SUNDRY NOTICES AND REPORTS ON WELLS

8. Well Name and No
ESTILL FEDERAL AD # 19. API Well No
30-015-2211810. Field and Pool, or Exploratory Area
WHITE CITY PENN11. County or Parish, State
EDDY CO, NM

CHEVRON USA INC submits for your approval, new tank installations to accommodate the increase of production from the recent completion of the Canyon Cisco formation.

PROCESS FLOW DIAGRAM

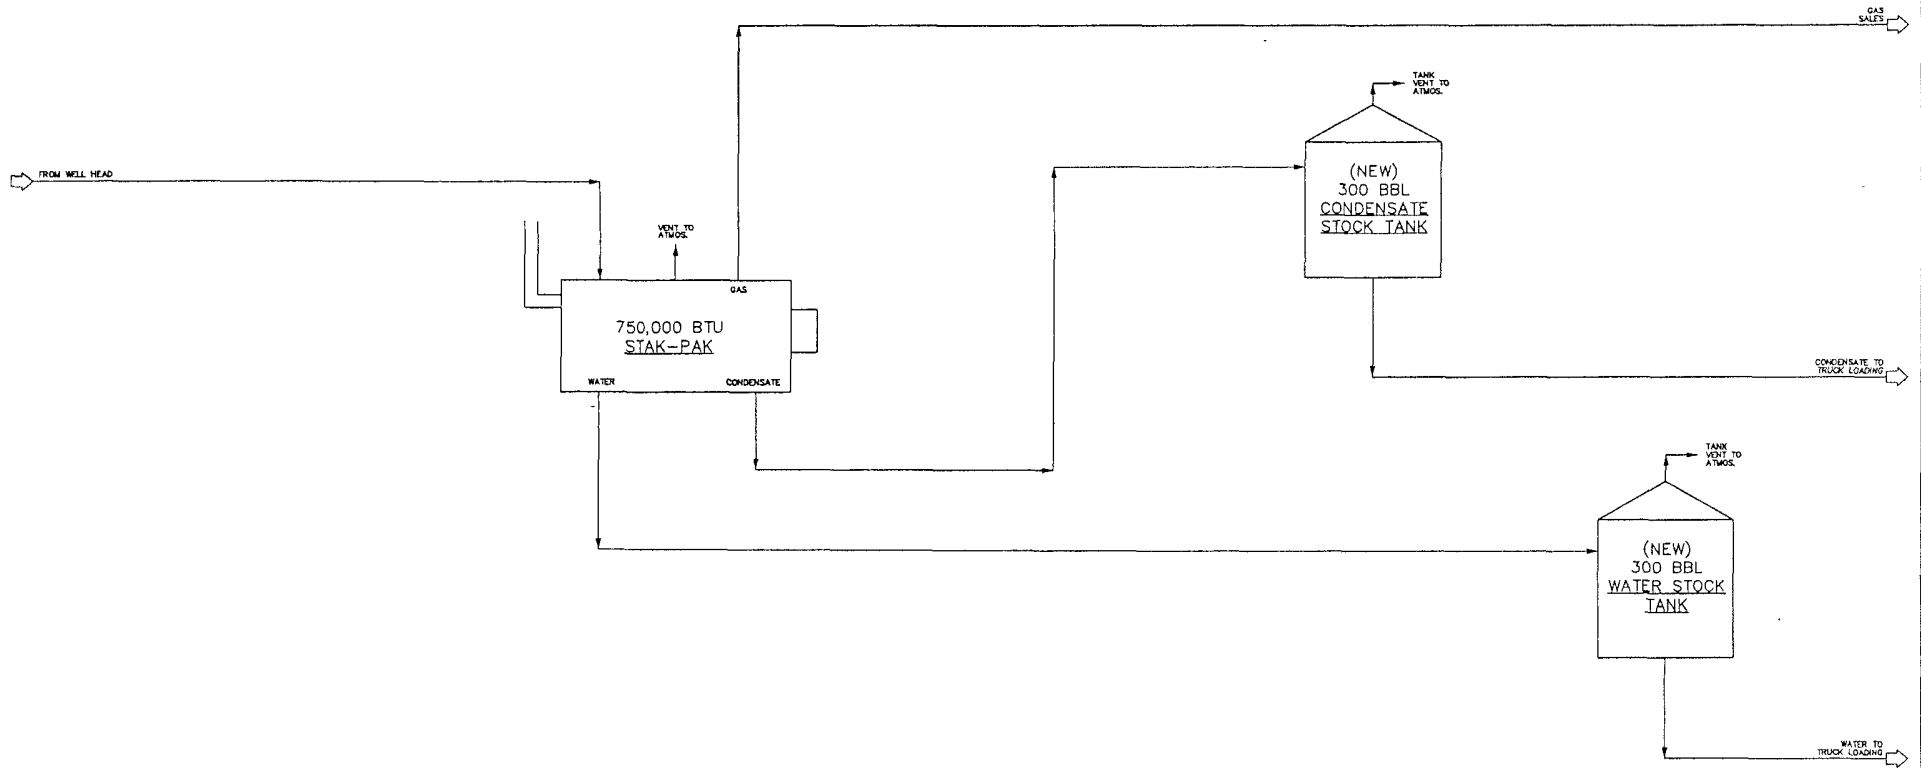
Chevron plans to remove the 210 BBL condensate tank, and install a new 300 BBL condensate stock tank, and the remove the 500 BBL. rental frac water tank, and install a new 300 BBL water stock tank.
